Departure from Design Standards DDS-628
Departure from Parking and Loading Standards DPLS-410

TECHNICAL STAFF REPORT

SUBJECT: **Departure from Design Standards Application No. DDS-628**
Departure from Parking and Loading Standards Application No. DPLS-410

PHILMATT-AFRIK, INC.

SITE PLAN

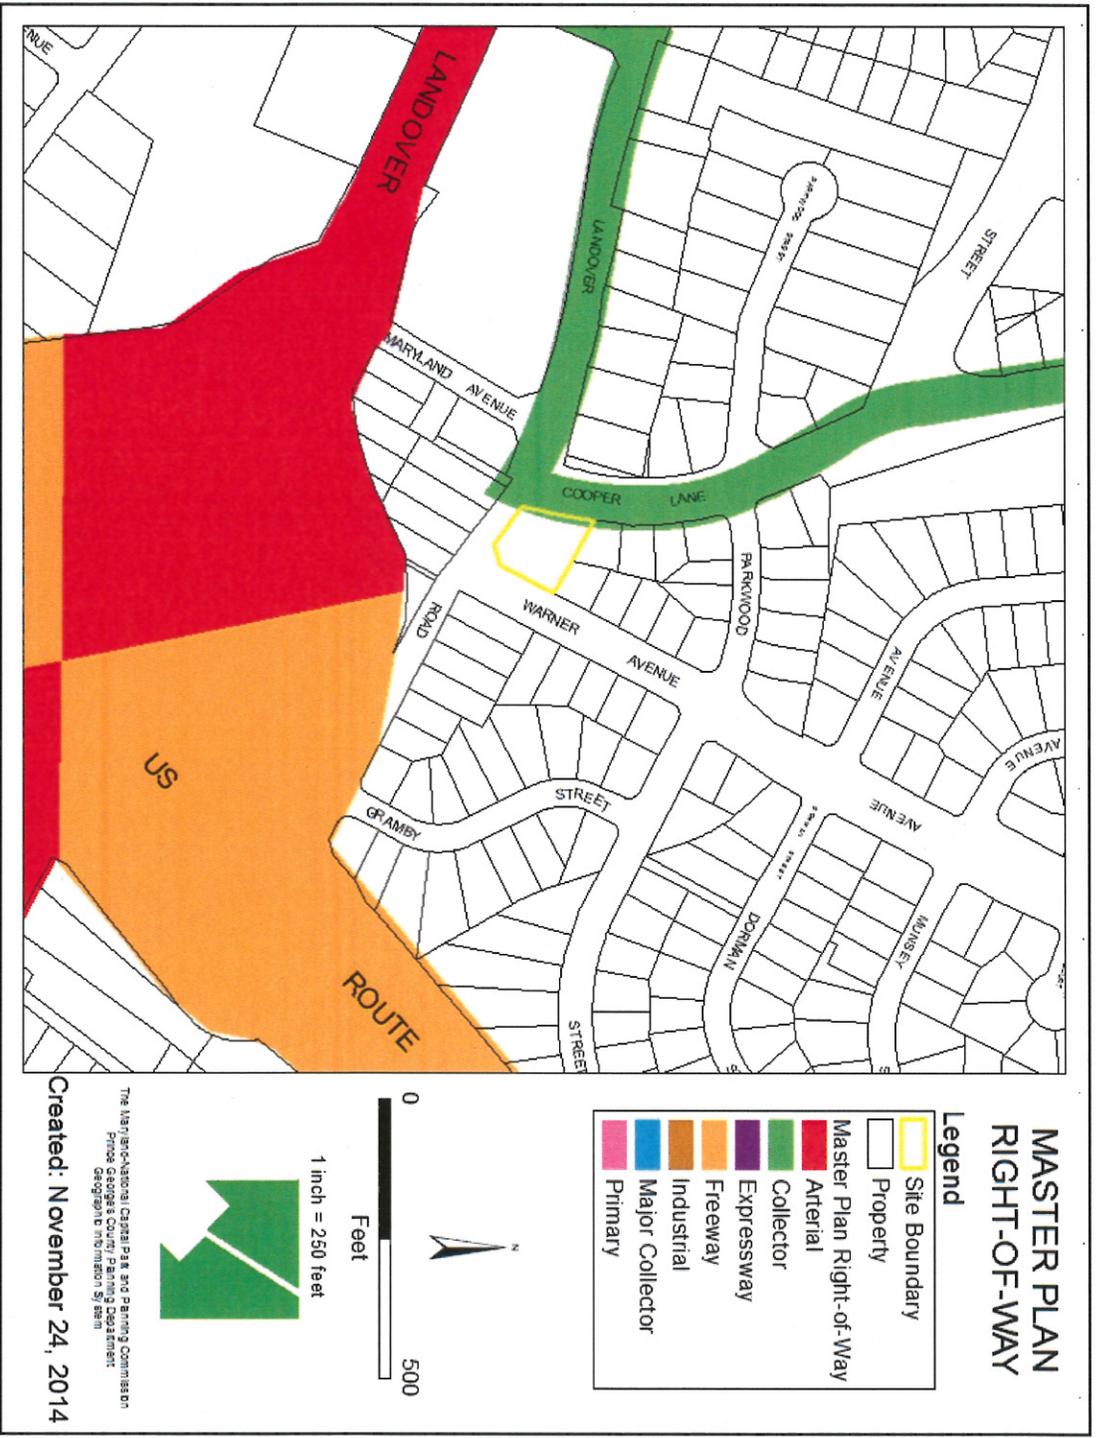
1. The site plan submitted does not match what is shown on an aerial photograph. The location of the dumpster must be demonstrated with required screening unless information is provided regarding where the trash will be stored. There are striped spaces that are on site that will have to be removed if they are not in conformance with zoning.

2. Dimension of the drive aisle must be provided on the site plan. It appears that the building was constructed in 1967, the applicant still has the option of using pre-1970 standards for parking and loading. Pre 1970 parking space size are 10 feet by 20 feet with a minimum of 18 foot drive aisle. New parking space size must be dimensioned at 9.5 by 19 feet in size. Compact parking spaces must also be dimensioned. Drive aisle widths for new parking must be shown on the site plan at 22 feet in size.

4. The site plan shall be reviewed to demonstrate the right-of-way and centerline of all streets.
5. The height and number of stories must be provided on the site plan

7. The site plan must be revised to demonstrate a ramp or depressed curb for handicap purposes.
8. The parking schedule is unclear, depending on the total square footage and number of stories will determine the parking required. The building previously had multiple tenants in it. The parking schedule shall clearly identify the total square footage of the building. The parking and loading ratio must be provided on the parking schedule.
9. The parking area across the street should be removed from the site plan, it has not been reviewed and should not be included in this request.

9. The parking area across the street should be removed from the site plan, it has not been reviewed and should not be included in this request.

1. The site plan submitted does not match what is shown on an aerial photograph. The location of the dumpster must be demonstrated with required screening unless information is provided regarding where the trash will be stored. There are striped spaces that are on site that will have to be removed if they are not in conformance with zoning. *(Dumpster (along w/ Bd-On Bd Fence) & Fence detail shown on plan)*

2. Dimension of the drive aisle must be provided on the site plan. It appears that the building was constructed in 1967, the applicant still has the option of using pre-1970 standards for parking and loading. Pre 1970 parking space size are 10 feet by 20 feet with a minimum of 18 foot drive aisle. New parking space size must be dimensioned at 9.5 by 19 feet in size. Compact parking spaces must also be dimensioned. Drive aisle widths for new parking must be shown on the site plan at 22 feet in size. *(Drive aisle widths & current parking dimensions shown on plan)*

4. The site plan shall be reviewed to demonstrate the right-of-way and centerline of all streets. *(R.O.W. & centerlines of adjacent streets shown on plan)*

5. The height and number of stories must be provided on the site plan. *(Height & Existing bldg stories shown on plan)*
6. Section 27-568(b) below allows for a reduction in the number of required parking spaces if interior green is added. *(No interior green proposed)*

7. The site plan must be revised to demonstrate a ramp or depressed curb for handicap purposes (Ramp for H/C parking shown on plan)

(Parking area removed from plan)
